**DEFENSE NUCLEAR FACILITIES  
SAFETY BOARD**

## Staff Report

### Review of the Preliminary Documented Safety Analysis for the High-Level Waste Facility

**Figure 2.** A plot of the LFL of hydrogen as a function of temperature (derived from [17]).

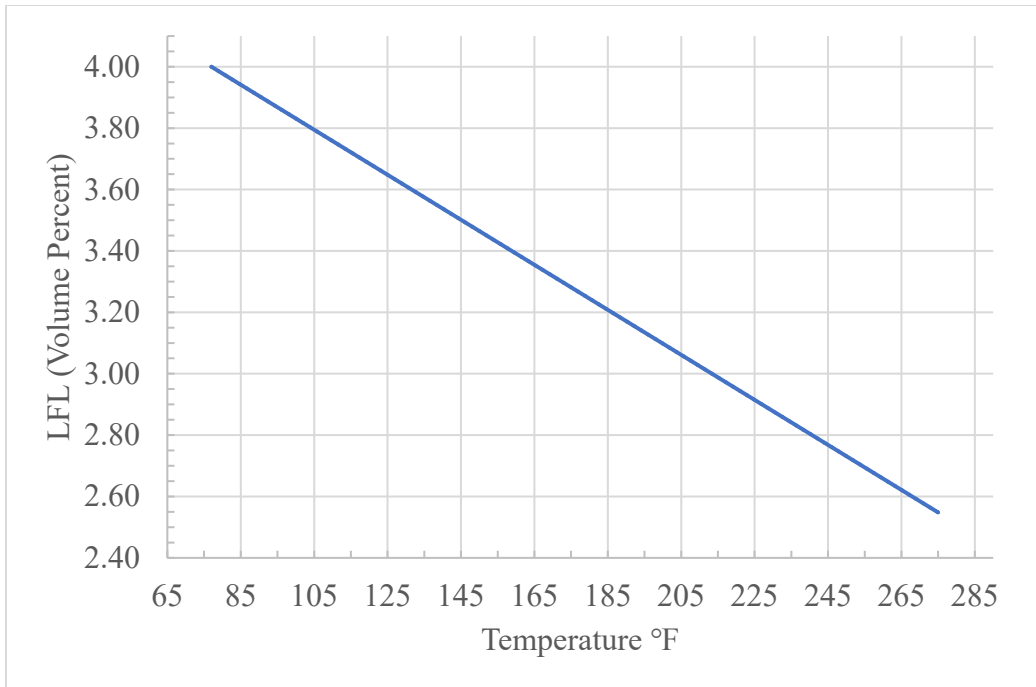
*Observation 4: Temperature Effects Are Not Fully Considered in the Volcanic Ashfall Safety Strategy*—As discussed, the control strategy for a volcanic ashfall event includes a passive safe shutdown of the facility that secures electrical power to all systems. With ventilation and other cooling systems shut down, the facility’s temperature will increase. This temperature increase was not considered in the safety analyses of hydrogen hazards during the ashfall event.

Project documents show that facility air temperatures could reach beyond 267 °F during the passive safe shutdown. There are three impacts to safety analyses for hydrogen hazards from an increased facility temperature:

1. Hydrogen generation rate increases with rising waste temperature. The hydrogen generation rate calculation is based on waste temperature in the HFP vessels. The waste temperature calculation assumes a maximum 113 °F ambient air temperature within the C5 confinement boundary that contains the HFP vessels [16]. A higher ambient air temperature will increase the waste temperature, which in turn, will increase the hydrogen generation rate.
2. Increased facility temperature impacts flow dynamics in the HFP vessel and connected piping post-explosion. The FATE™ calculation used to determine HOP HEPA filter survivability following an HFP vessel explosion assumes a maximum temperature within the C5 confinement boundary equal to 113 °F.
3. Hydrogen’s LFL decreases with rising temperature. Figure 2 illustrates this effect.

DOE Standard 3009-94 states: “The range of accident scenarios analyzed in a DSA [documented safety analysis] should be such that a complete set of bounding conditions to define the envelope of accident conditions to which the operation could be subjected are evaluated and documented.” Project personnel plan to update the safety analyses for a volcanic ashfall event to consider the increased facility temperatures during the passive safe shutdown. They expect revised analyses to show that the facility temperatures will be lower than originally calculated. Project personnel are also evaluating how safety systems will be impacted by the increased air temperatures.
